# Compliance Statement Berwick Green Design Code

Parcels 5, 6 & 7  
Residential Development

Ref. 22016.900 version 2

Prior to completion of this Reserved Matters, initial views on the proposals were sought via a Pre-Application Advice submission ref. PRE23/0312. In response to the consultation comments received at the pre-application stage, please note the following:-

*Design Code: Managing Levels Plan  
(Extract Plans from 'Land North of Cribbs Causeway (Berwick Green)', Design Code - February 2022 - Produced by Barton Willmore)*

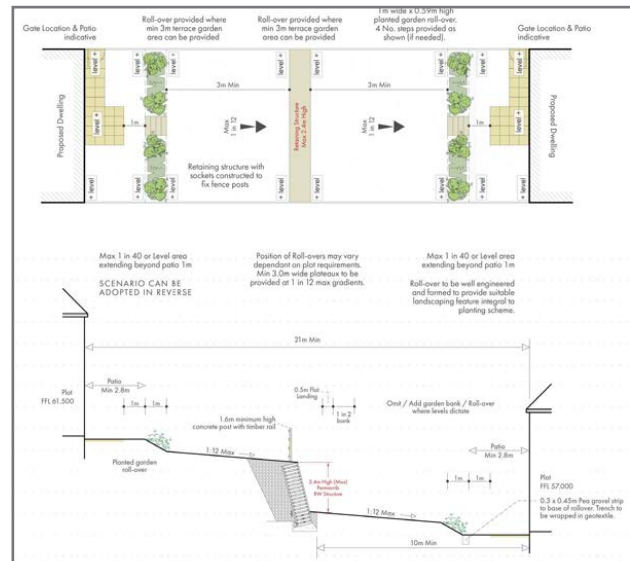
- We note the comment regarding the 1:2 slope shown within the rear gardens but consider these areas can be landscaped as detailed within the Design Code;
